Riverside Medical Office Build-Out

BREAK ROOM 118 CASEWORK & QUARTZ COUNTERTOP PLAN, ELEVATIONS & SCHEDULE

SD-1

DRAWING TITLE
BREAK ROOM 118
COUNTERTOP & CASEWORK
DETAILS & SLAB LAYOUT

1 COUNTERTOP & CASEWORK PLAN - BREAK ROOM 118

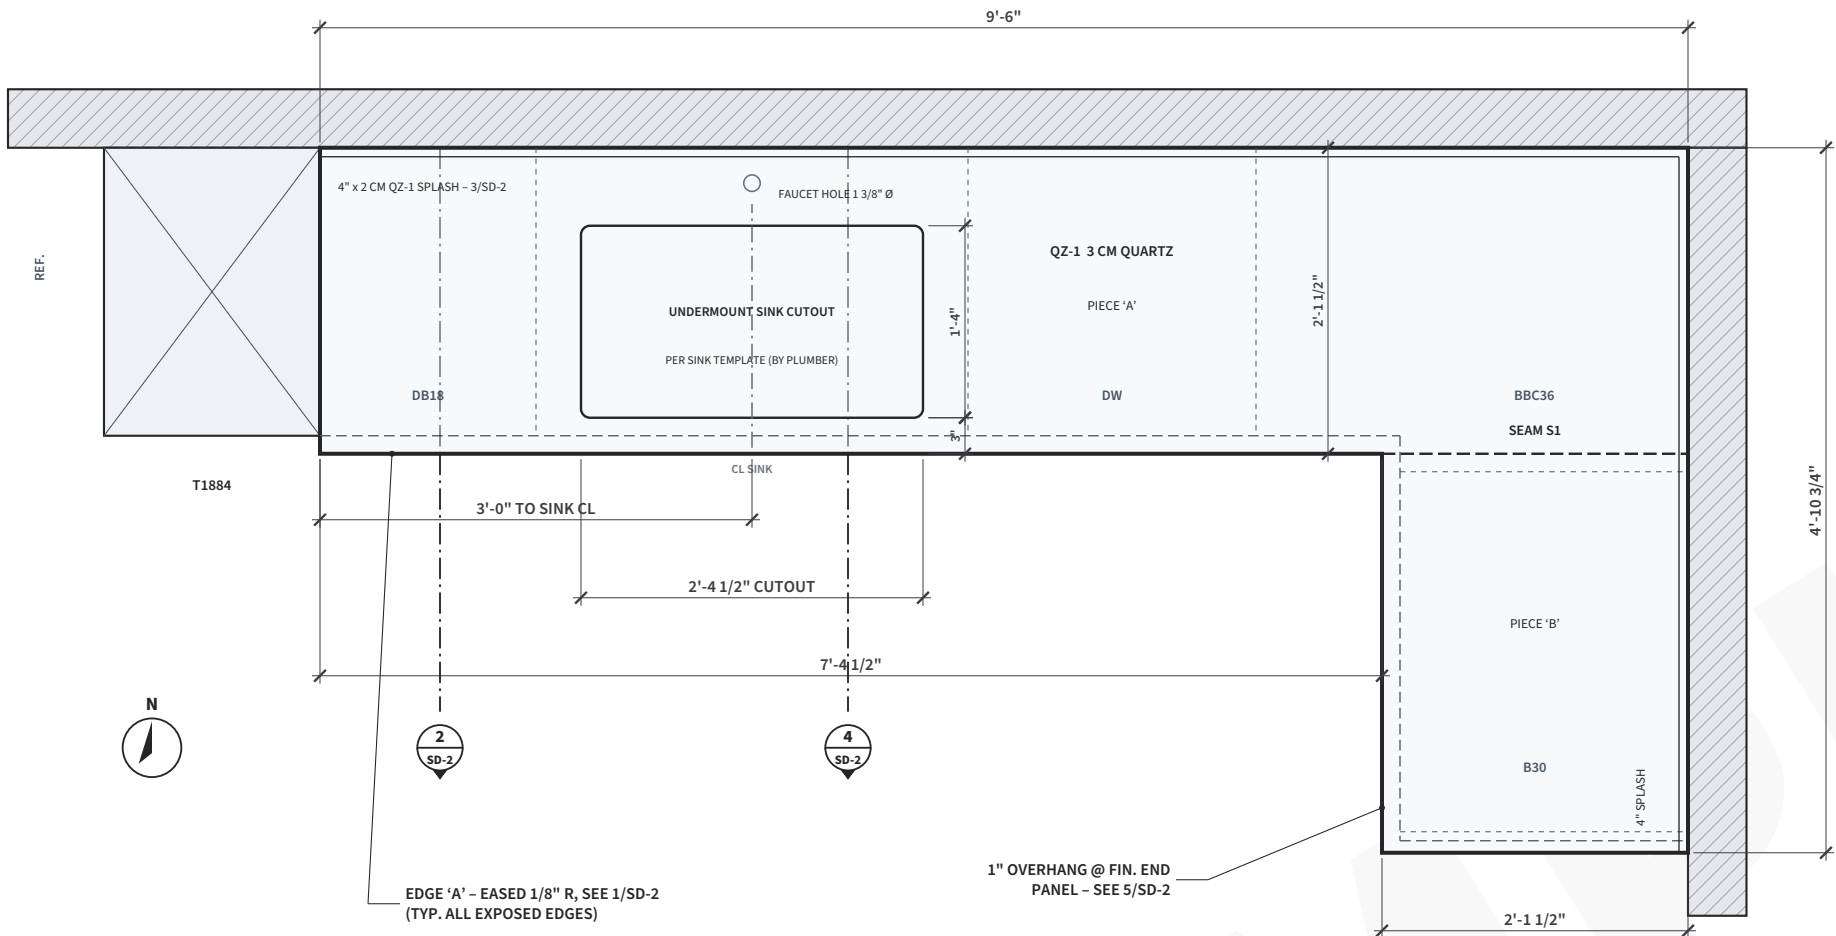
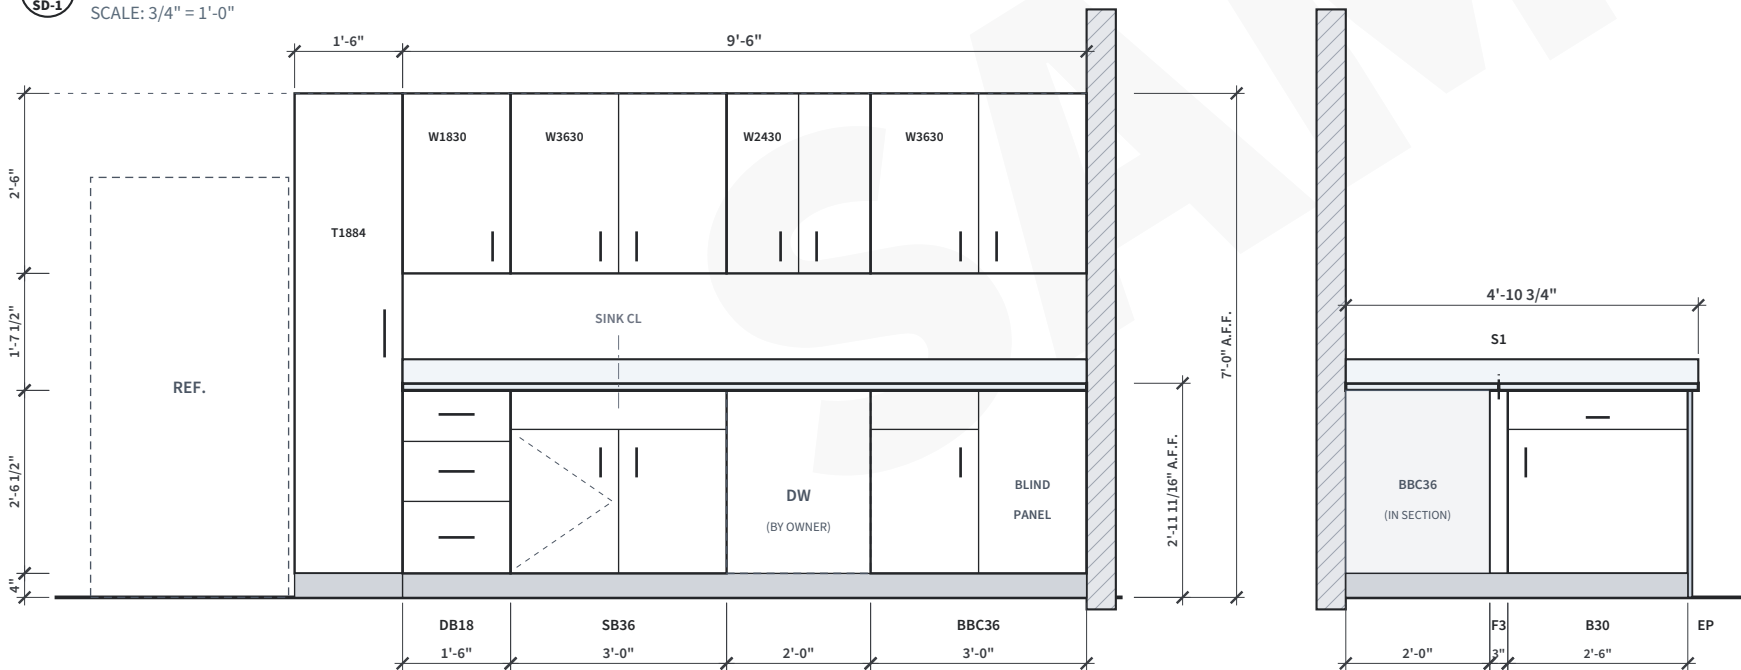
P. Nair, Lumen Architecture Studio - 10/02/26
Note: verify sink CL at rough-in (see Rev 1).

4 **UNDERMOUNT SINK SECTION**
SD-2 SCALE: 1 1/2" = 1'-0"

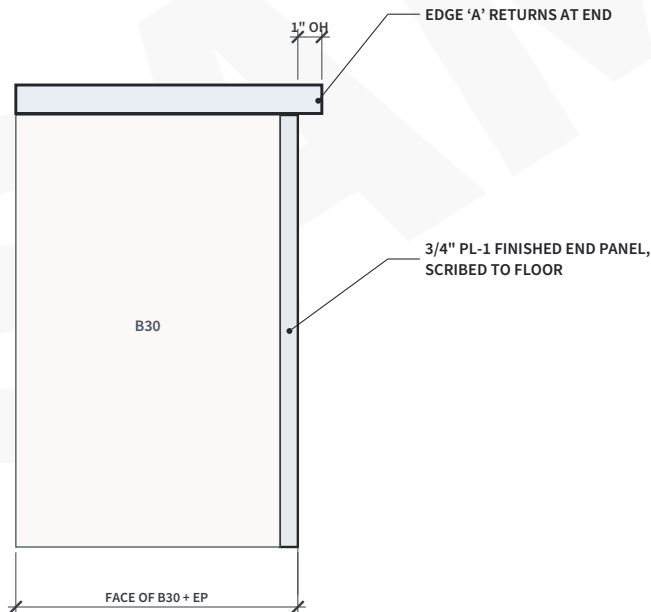
P. Nair, Lumen Architecture Studio – 10/02/26
Note: verify sink CL at rough-in (see Rev 1).
